Re: Contract 200-2004-03805, Task 1, Supplement to SCA-TR-TASK1-0004:
Draft Review of the Hanford Site Profile

**ADVISORY BOARD ON
RADIATION AND WORKER HEALTH**
National Institute of Occupational Safety and Health
**Review of NIOSH Site Profile
for the
Hanford Site, Richland, Washington**

SCA-TR-TASK1-0004

Figure 1. Neutron/Photon Dose Ratio Distribution of Hanford Plutonium Facility Workers

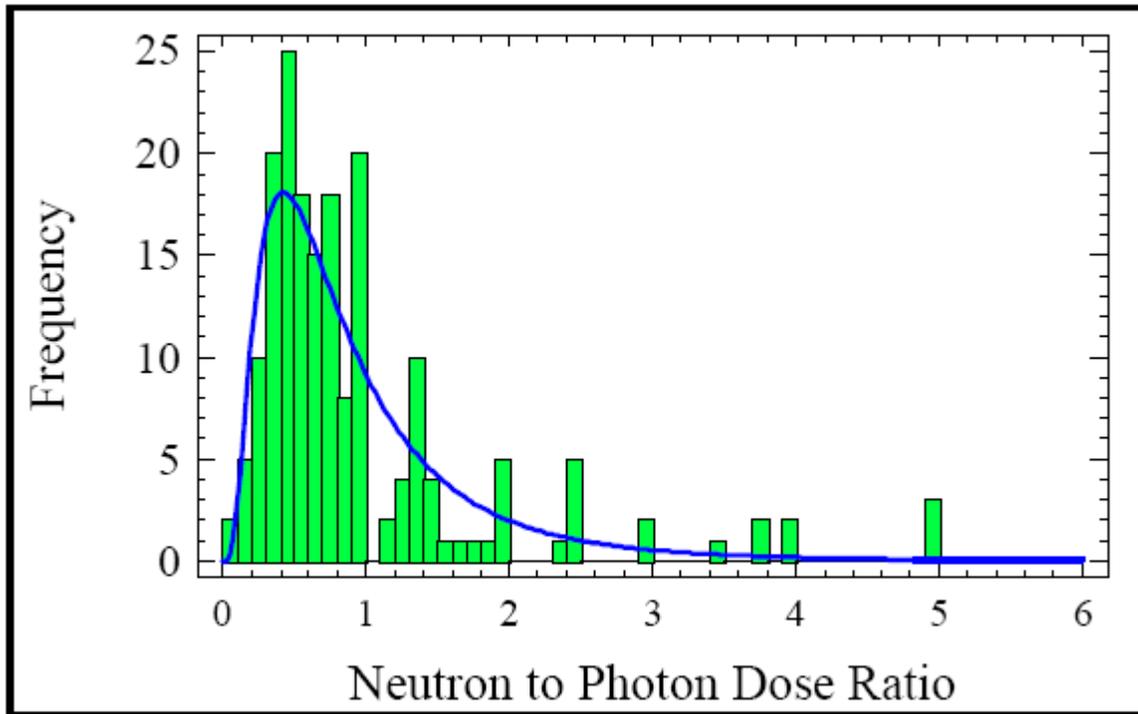
The results of the 186 matched dosimeter readings were evaluated in terms of their neutron-to-photon ratios and yielded a distribution that is depicted in Figure 1. The data show a wide range in values with maximum neutron-to-photon ratios of up to 5.0.

From this data set, NIOSH calculated a neutron-to-photon ratio with a geometric mean of 0.73, a geometric standard deviation of 2.10, and a 95th percentile value of 2.47.

Figure 3. Estimate of Personnel Having Work Potentially Involving Exposure to Recycled Uranium at Specific Facilities

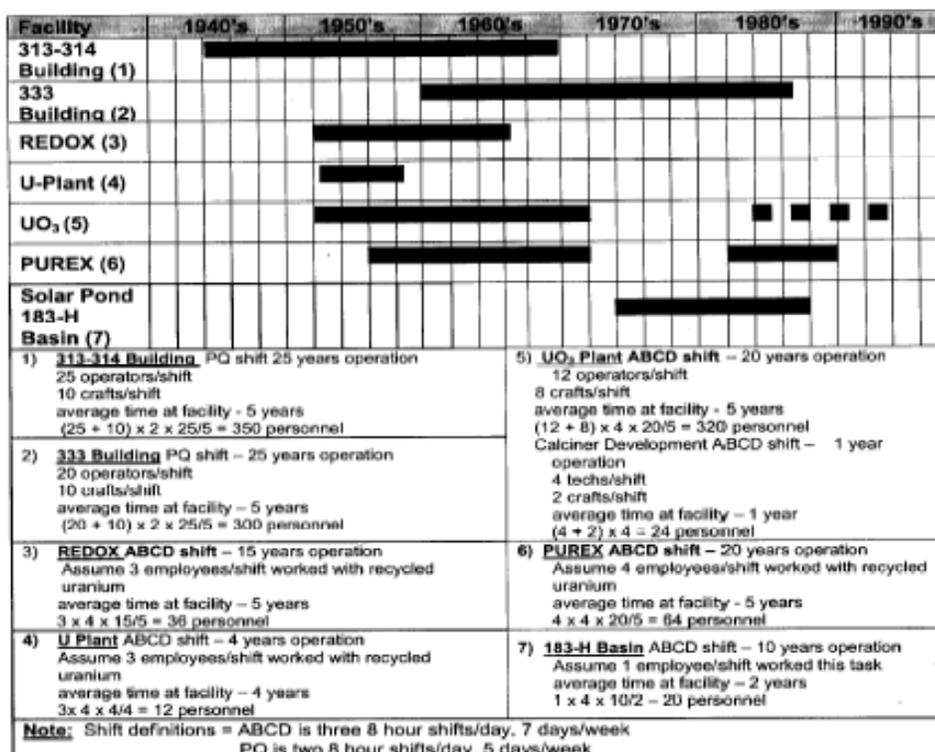
According to a 2000 DOE assessment of recycled uranium at Hanford (see Figure 3):

The facilities that were identified to have involved the handling of recycled uranium included (1) the 313-314 building complex in the 300 area which was primarily involved in the fabrication of aluminum-clad reactor fuels; (2) the 333 building complex in the 300 Area, which was involved in the fabrication of zirconium-clad reactor fuels; (3) the REDOX chemical separations plant in the 200 West Area where reactor fuels were dissolved for plutonium and uranium (including transfer of the UNH to the UO₃ Plant for calcinations), (4) the U plant in the 200 West Area where pre-1952 tank wastes were processed for uranium
